CRAIG SEAPLANE BASE EXPANSION

PROJECT No. 69956
A.I.P. # 3-02-0071-01

DATE: JULY 1994

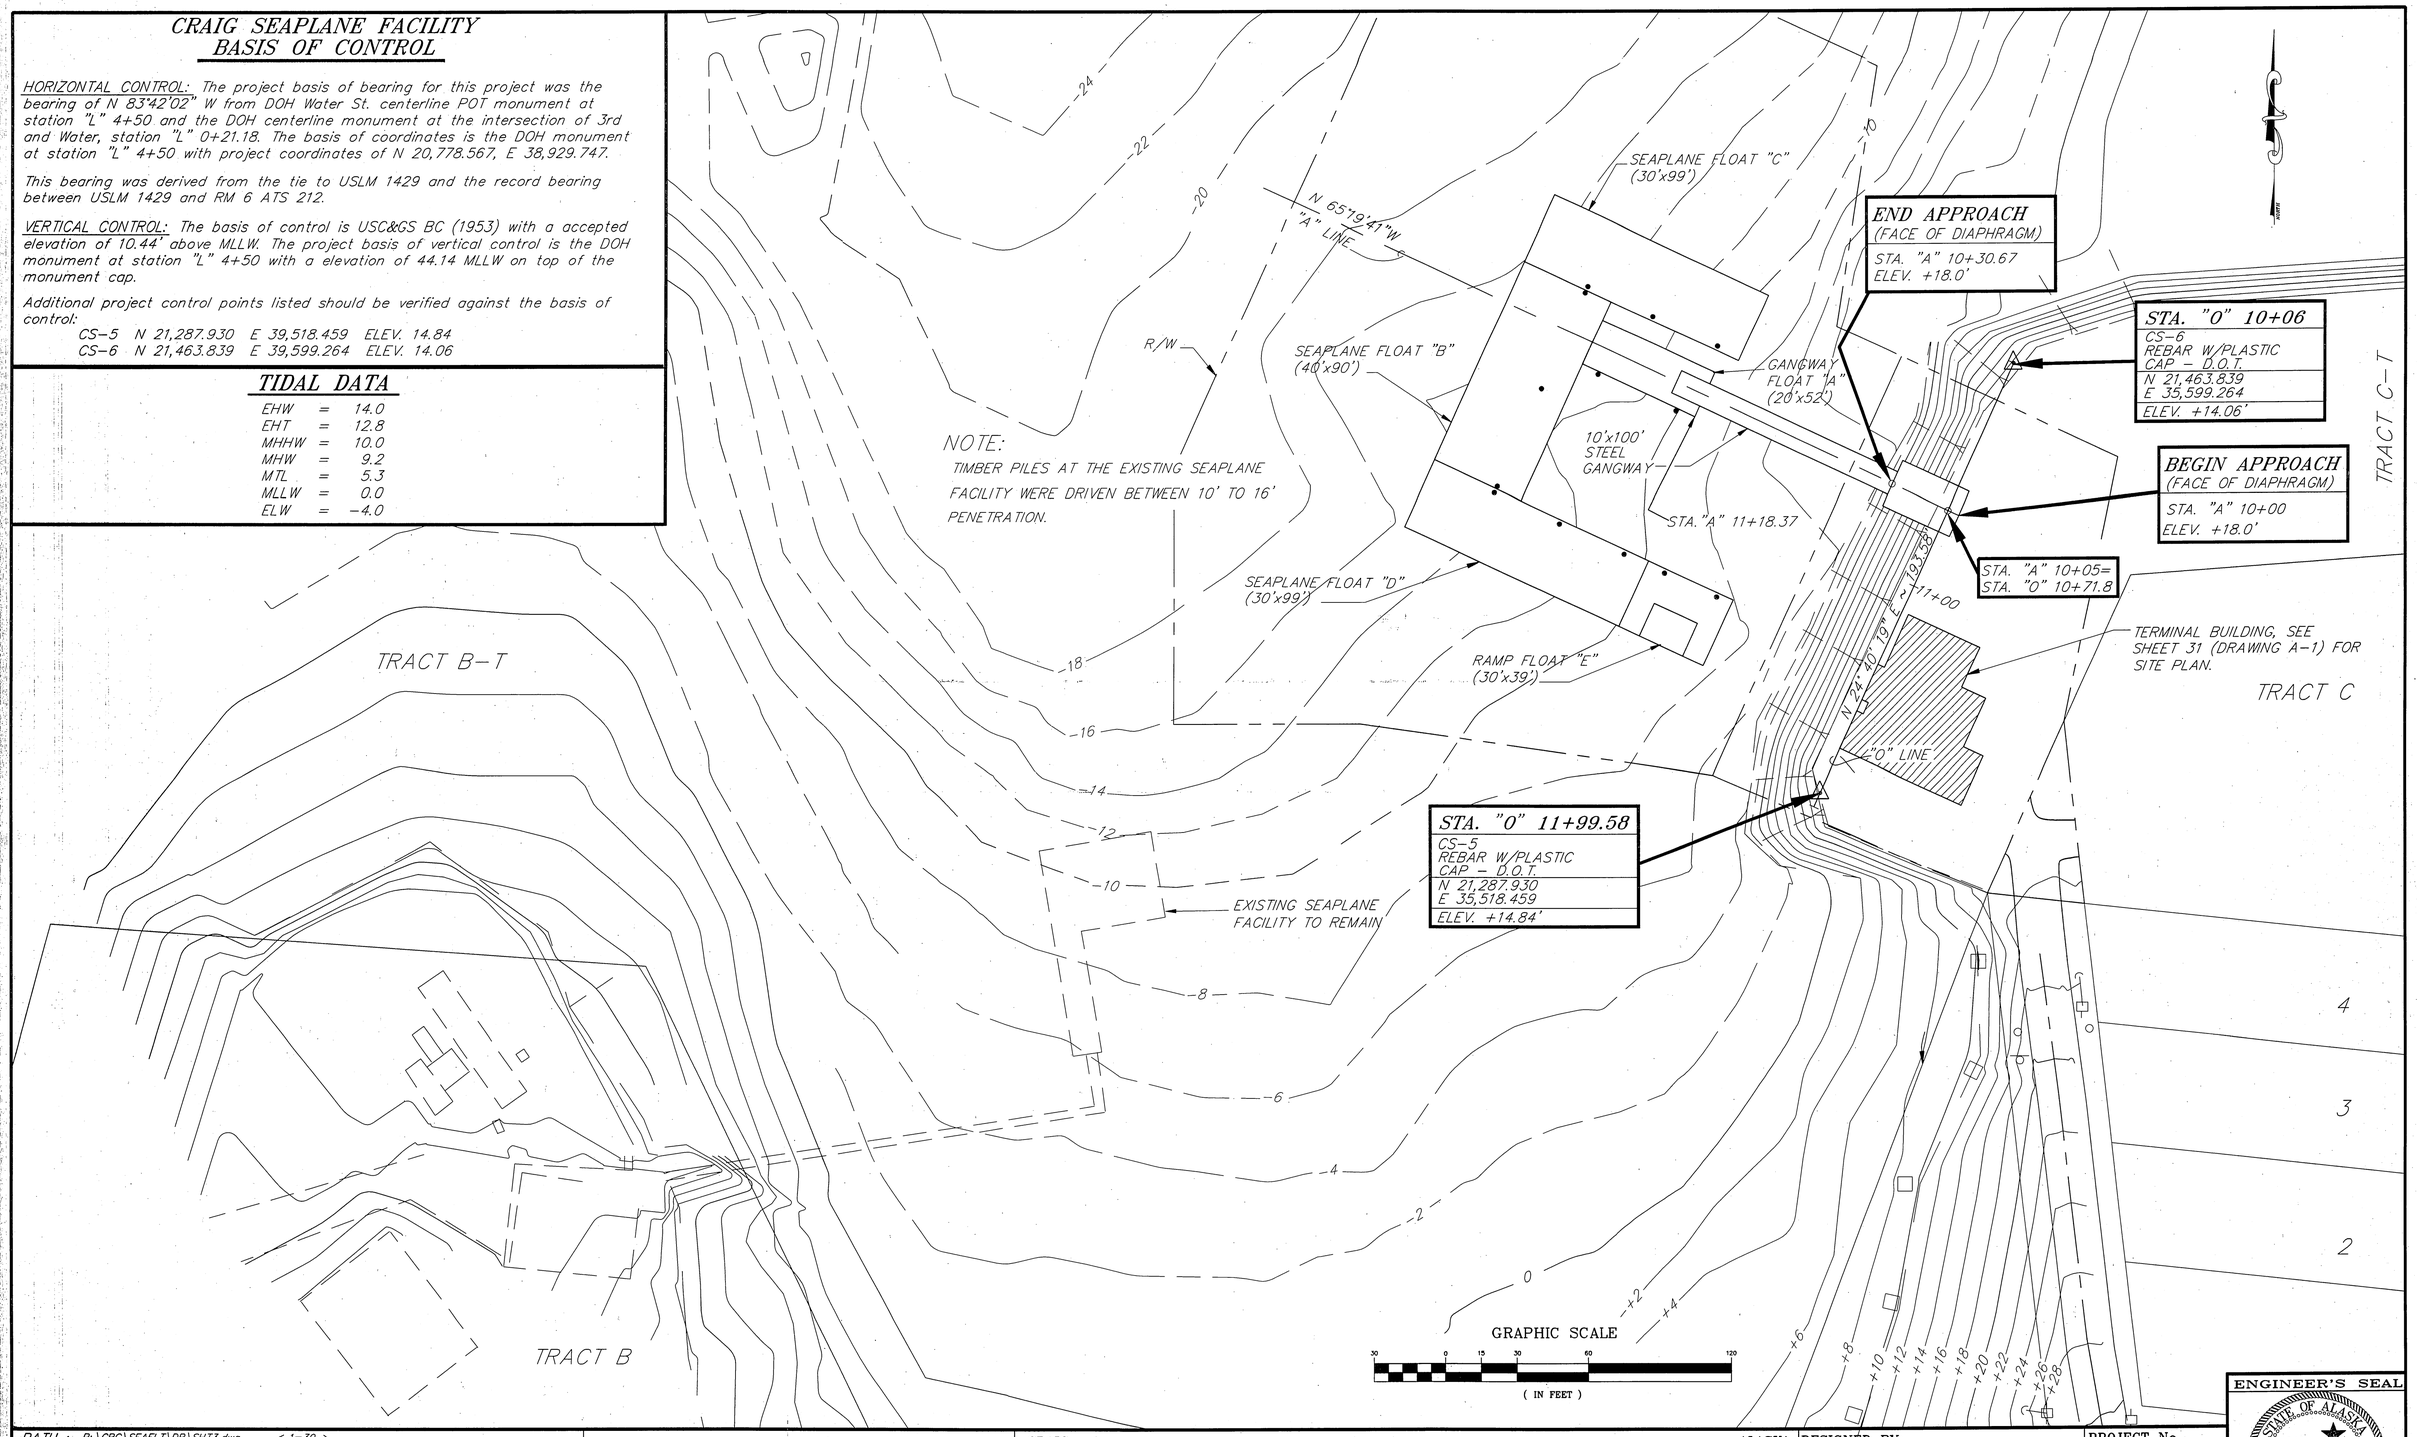
PATH : P:\CRG\SEAFLT\DR\SHT3.dwg < 1=30 >		
BY	DATE	DESCRIPTION OF CHANGE
D.D.S.	8/31/94	DISTANCE BETWEEN END OF APPROACH & BEGINNING OF
		FLOAT "E" WAS REVISED FROM 87'-0" TO 87'-8 1/2"
		(ADDENDUM NO.1).

CRAIG ALASKA
CRAIG SEAPLANE BASE EXPANSION
A.I.P. # 3-02-0071-01
APPROACH PLAN & ELEVATION

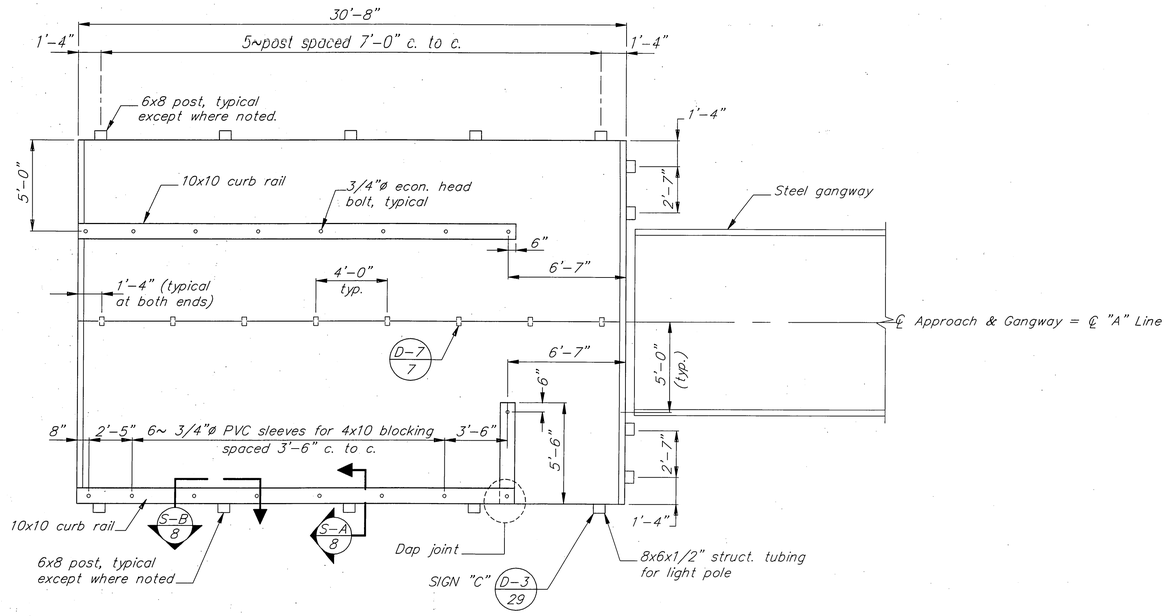
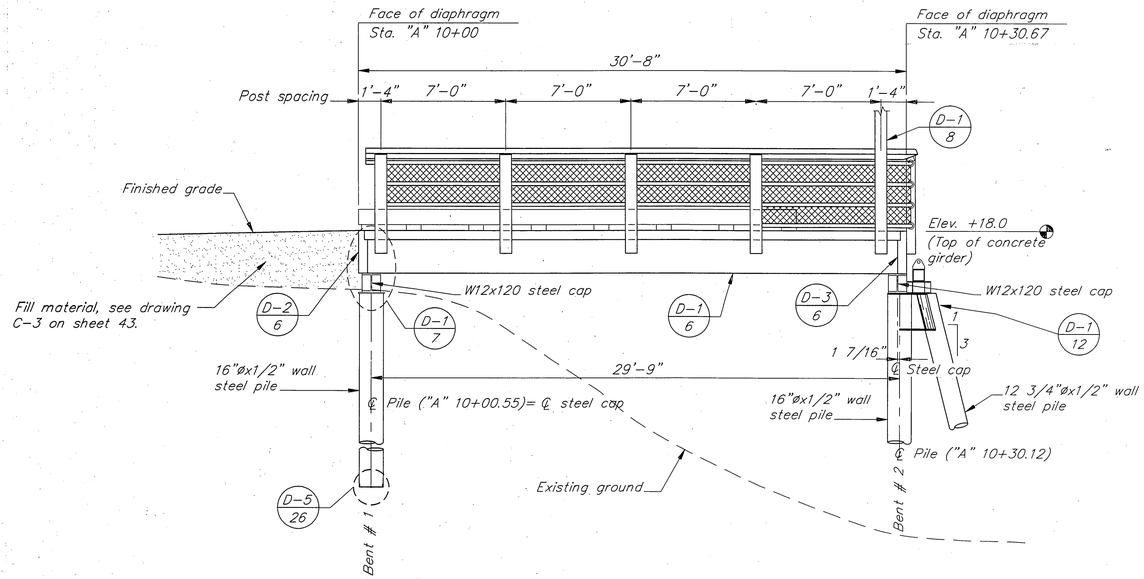
BY	DATE	DESCRIPTION OF CHANGE
D.D.S.	8/31/94	THE 6x8 LUMINAIRE POLE WAS MOVED TO THE END OF APPROACH (ADDENDUM NO. 1).

LIGHT POLE DETAIL AT APPROACH — 1

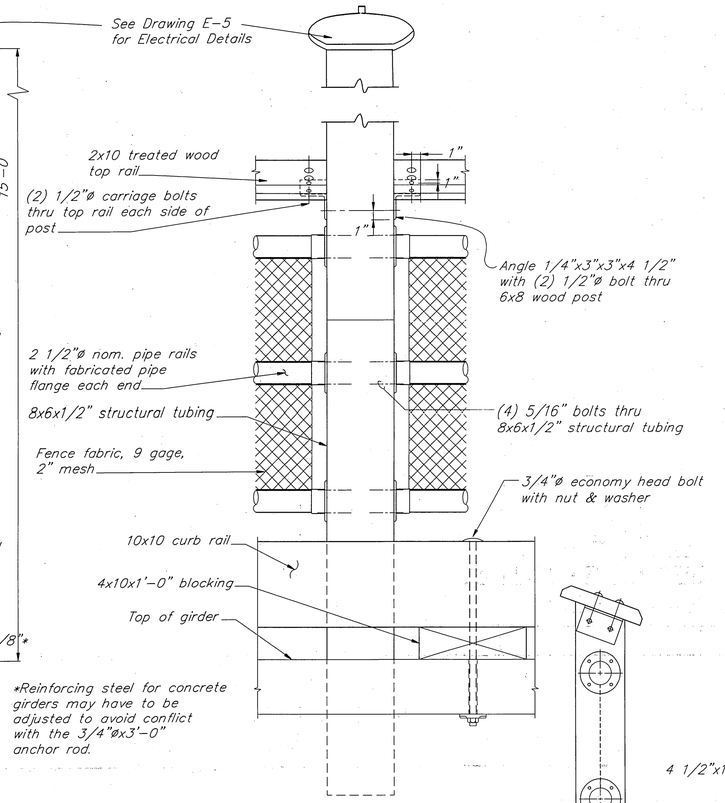
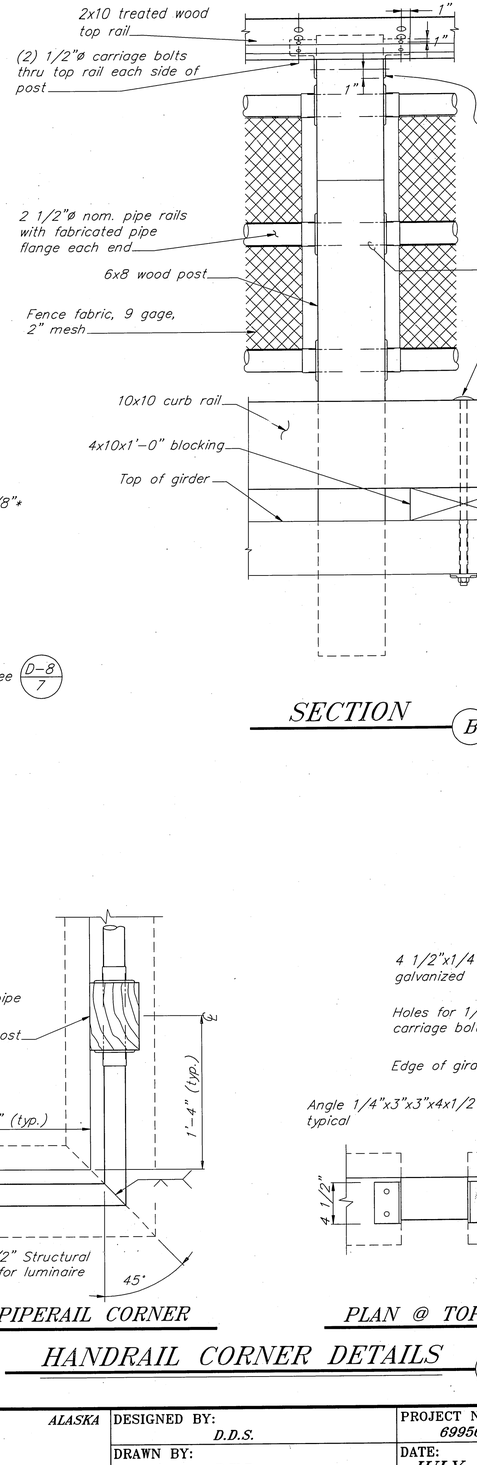
PATH : P:\CRG\SEAFLT\DR\RAILDET.dwg < 1=8 >		
BY	DATE	DESCRIPTION OF CHANGE
DDS	8/31/94	DETAIL 3 & SECTION C WERE REVISED TO REFECT THE
		NEW LOCATION OF THE 6x8 LUMINAIRE POLE
		(ADDENDUM NO. 1)

ELEVATION

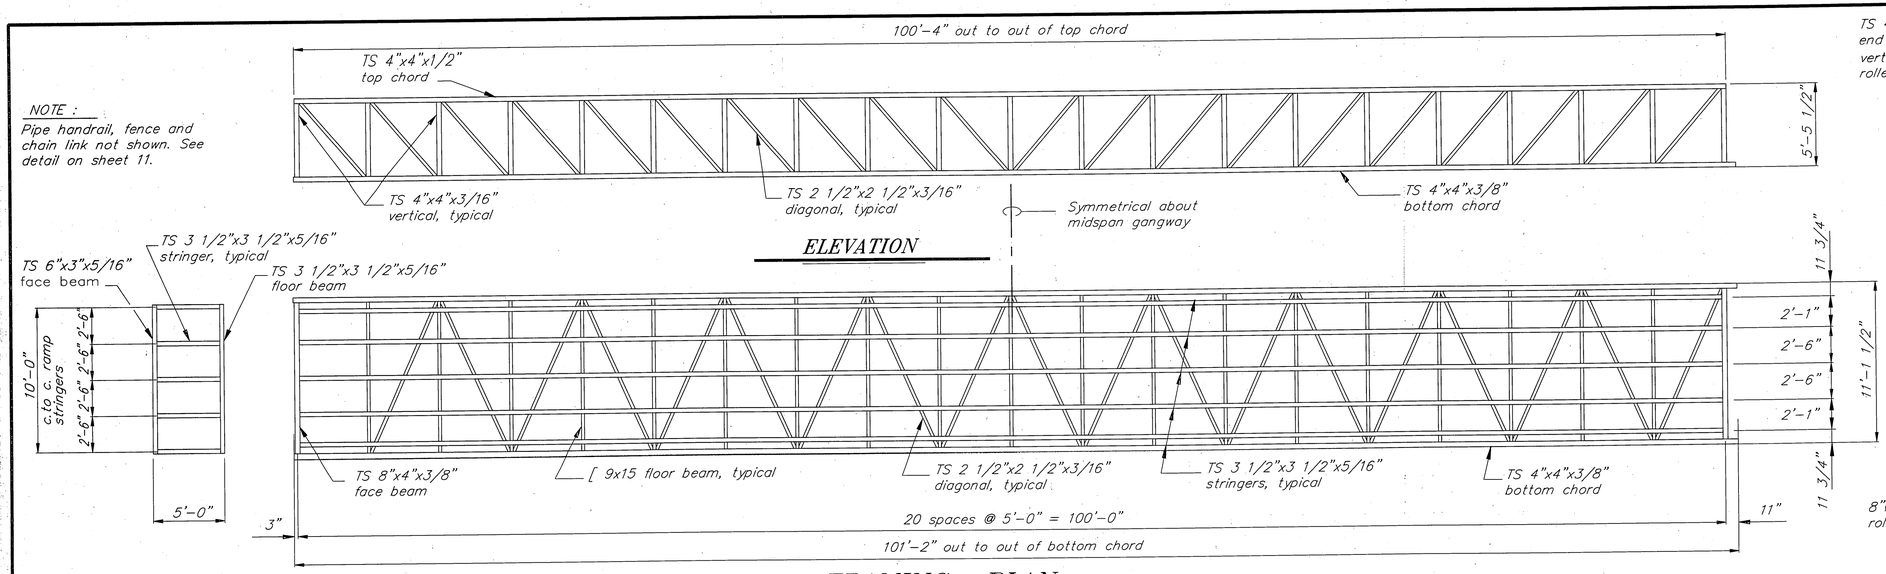
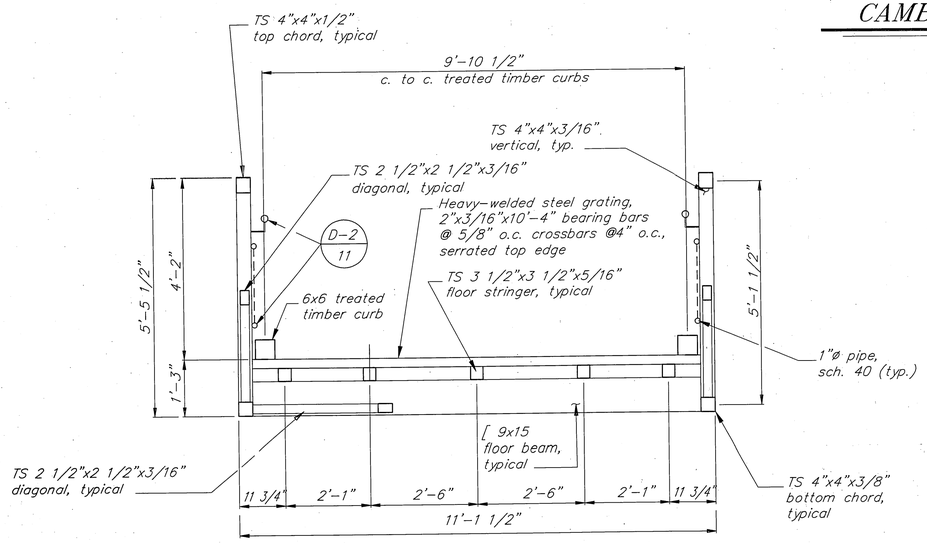
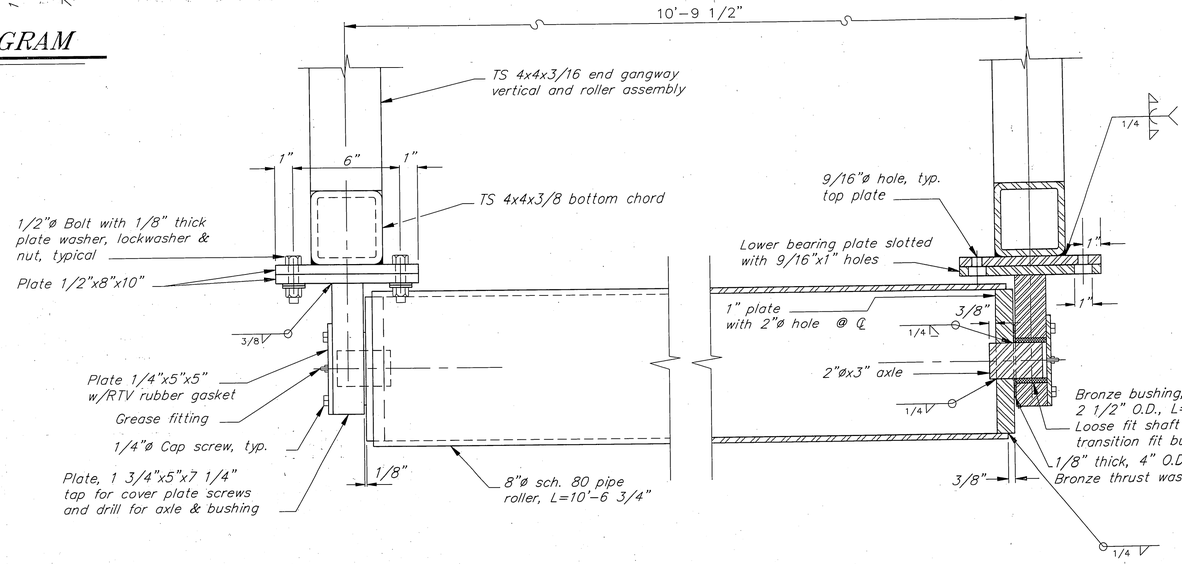
PATH : P:\CRG\SEAFLT\DR\SH19.dwg < 1=5 >		
BY	DATE	DESCRIPTION OF CHANGE
DDS	8/31/94	THE HEIGHT OF GANGWAY WAS REVISED TO SHOW
		5'-5 1/2". THE BEARING GUIDE (SEE BEARING GUIDE
		ASSEMBLY) WAS DELETED (ADDENDUM NO. 1)

SWIVEL WELDMENT DETAIL 2

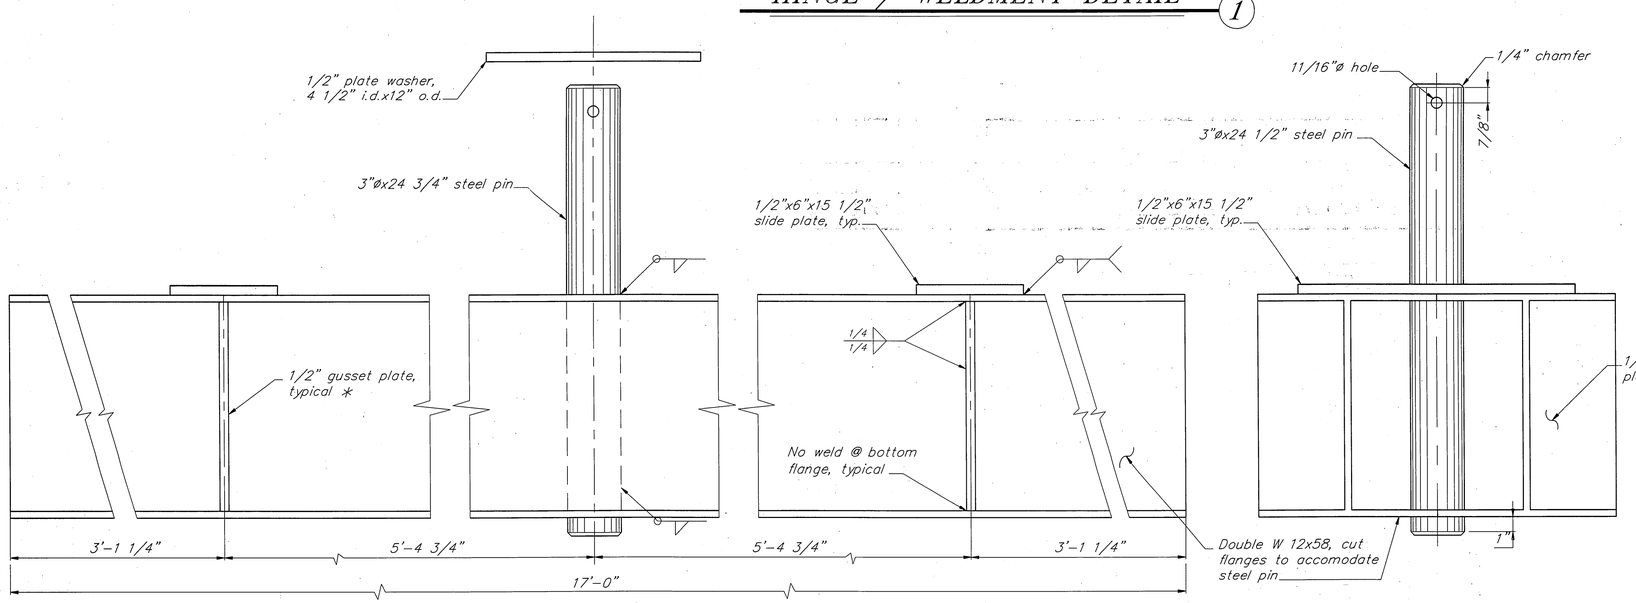
PATH : P:\CRG\SEAFLT\DR\GWDET5.dwg < 1=4 >		
BY	DATE	DESCRIPTION OF CHANGE
DDS	8/31/94	THE LENGTH OF THE DOUBLE W12X58 (SWIVEL WELDMENT
		DETAIL) WAS CORRECTED TO SHOW 17'-0"
		(ADDENDUM NO. 1).
